CITY OF ROCHESTER HILLS

**RE: St. Paul's Albanian Catholic Church
Auburn Road Improvements**

DATE: January 12, 2000

RE: St. Paul's Albanian Catholic
Church 98-037

MINIMUM PASSING FLARE TREATMENT

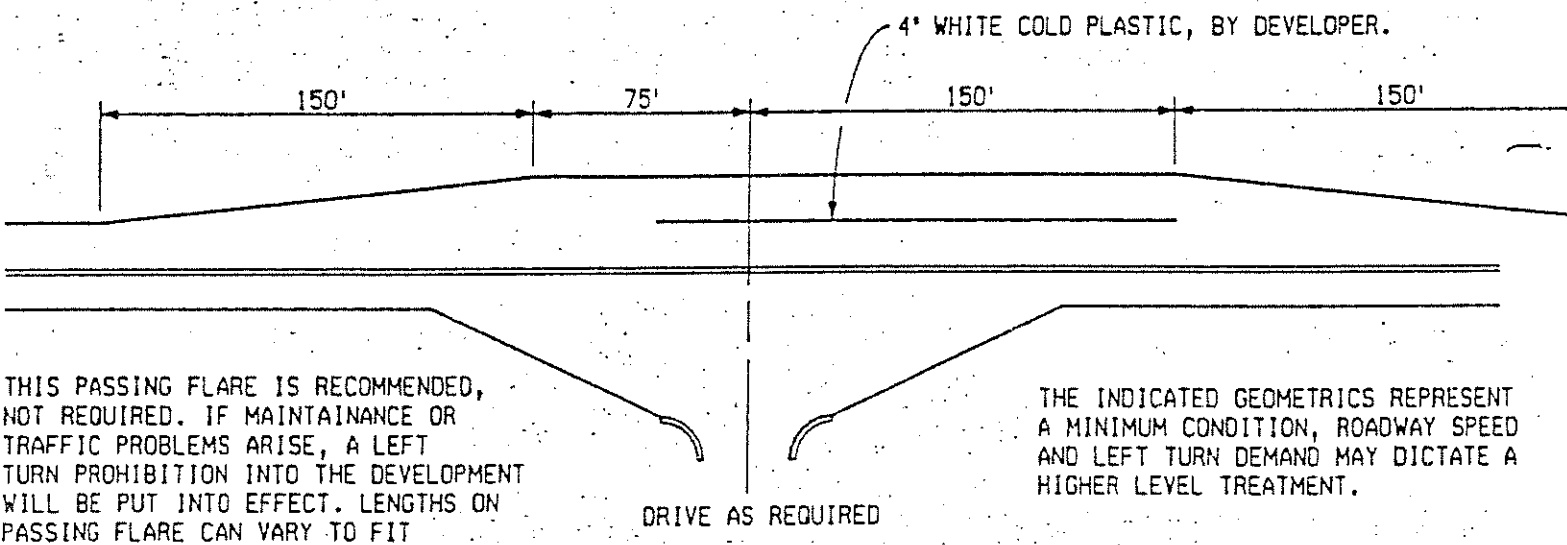
This work was suppose to compliment the widening on Auburn for the Rochester Hills Heathers development on Harrington Dr. However, after these comments were generated, MDOT chose not to permit a center left lane on Auburn at Harrington, requiring instead a passing lane configuration from the developer of the Heathers subdivision. This in turn modified my recommendation to St. Paul's Church, changing it from a center left turn lane to a passing lane to reflect the decision MDOT has already made for the neighboring development. I believe that there will not be any problem receiving MDOT approval for a passing lane for St. Paul's.

To answer the question of the likely scope of the widening, attached is a standard detail from MDOT for a passing lane. Applied in this particular circumstance, the passing lane would substantially fill the distance between Harrington and Walbridge Drives on the north side of Auburn.

THIS PASSING FLARE IS RECOMMENDED, NOT REQUIRED. IF MAINTAINANCE OR TRAFFIC PROBLEMS ARISE, A LEFT TURN PROHIBITION INTO THE DEVELOPMENT WILL BE PUT INTO EFFECT. LENGTHS ON PASSING FLARE CAN VARY TO FIT EXISTING CIRCUMSTANCES.

THE INDICATED GEOMETRICS REPRESENT A MINIMUM CONDITION, ROADWAY SPEED AND LEFT TURN DEMAND MAY DICTATE A HIGHER LEVEL TREATMENT.
